Access Compliance Report

Public Rights-of-Way

(Curb Ramps)

Intersection ID: 13763	Main Street: CENTRAL_AV	Cross Street: EASTWAY_DR	Location: SW
ADA ID: 86E18DBF6A69	Ramp Type: Perp	Initial Pass/Fail: Fail	Overall Compliance: No
		Severity Score: 10

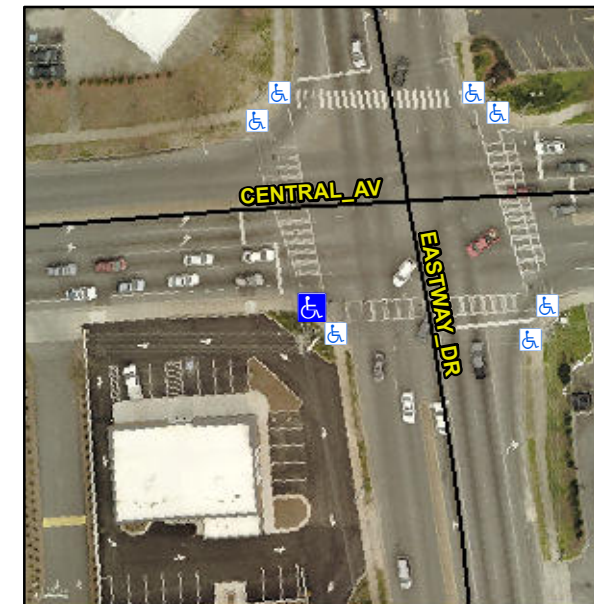
Not Found, R304.5.1, R304.5.3

Compliance	Description	Data	Compliance	Description	Data
N/A	Ramp Length (in)	72.0	Yes	Ramp Slope (%)	6.4
No	Ramp Width (in)	39.0	No	Ramp XSlope (%)	2.9
N/A	Flare Type LT	N/A	N/A	Flare Type RT	N/A
N/A	Flare Slope LT (%)	N/A	N/A	Flare Slope RT (%)	N/A
N/A	Flare Traversable LT?	N/A	N/A	Flare Traversable RT?	N/A
N/A	Landing Length (in)	N/A	N/A	DWS Provided?	N/A
N/A	Landing Width (in)	N/A	N/A	DWS Contrast?	N/A
N/A	Landing Slope (%)	N/A	N/A	DWS Length (in)	N/A
N/A	Landing X Slope (%)	N/A	N/A	DWS Full Width?	N/A
N/A	Landing Curb? (Y/N)	N/A	N/A	DWS Offset (in)	N/A
N/A	Shared Landing?	N/A			
N/A	Gutter Ponding?	N/A	N/A	Gutter Slope (%)	N/A
N/A	Gutter Lip Ht (in)	N/A	N/A	Gutter X Slope (%)	N/A
N/A	Painted X Walk1?	Yes	N/A	Painted X Walk2?	N/A
	X Walk 1 Direction	To N		X Walk 2 Direction	N/A
N/A	X Walk 1 Width (in)	115.0	N/A	X Walk 2 Width (in)	N/A
	X Walk 1 Slope (%)	4.8		X Walk 2 Slope (%)	N/A
	X Walk 1 X Slope (%)	2.1		X Walk 2 X Slope (%)	N/A

Remove & Replace Entire Ramp.
